ADDENDUM

Project Name: Recreation Authority of Roseville and Eastpointe
Recreation Authority Center
Addition and Renovation **Addendum No: Two (2)**

Project Number: 13-162 Issue Date: June 16, 2014

Project Location: Roseville, Michigan

DRAWING NO:
 SKA-01

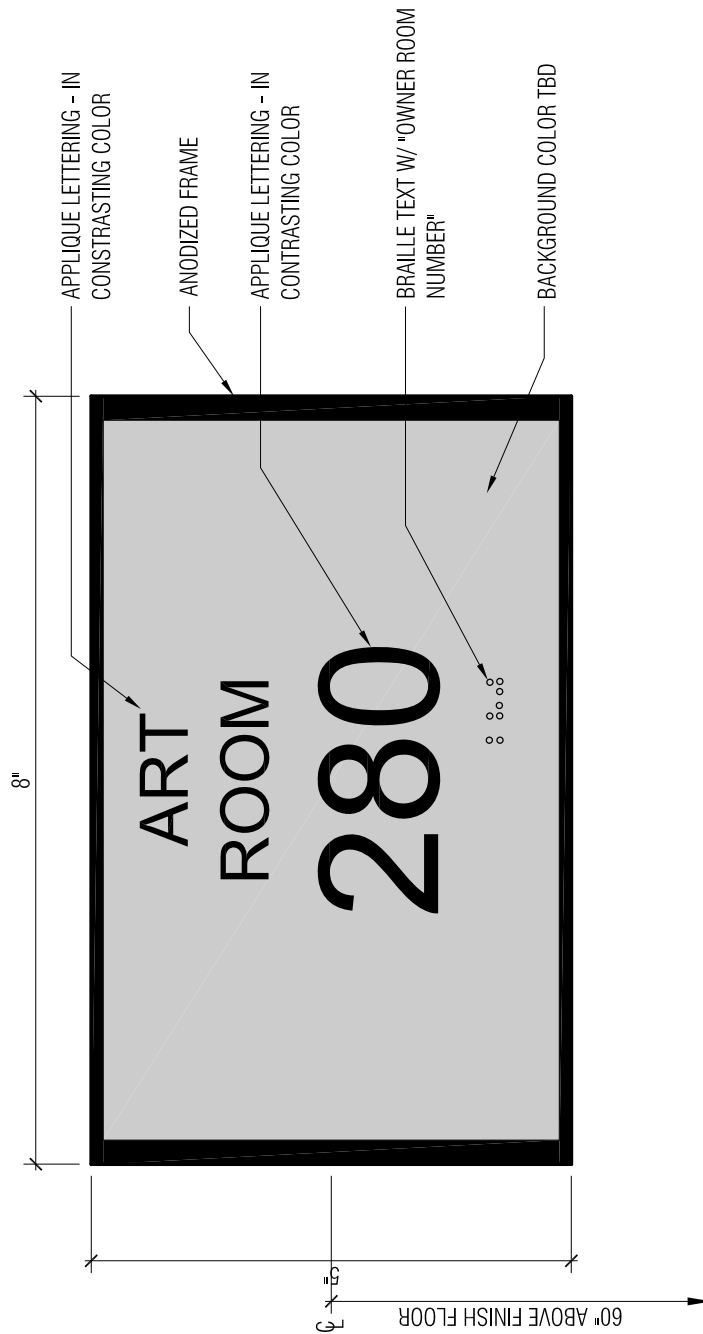
- B. Refer to sketches SKA-1, SKA-2, and SKA-3, (issued with this addendum) for sign type layout and requirements.
- ITEM SP10** Specification Section 122413 ROLLER SHADES: (revised but not re-issued)
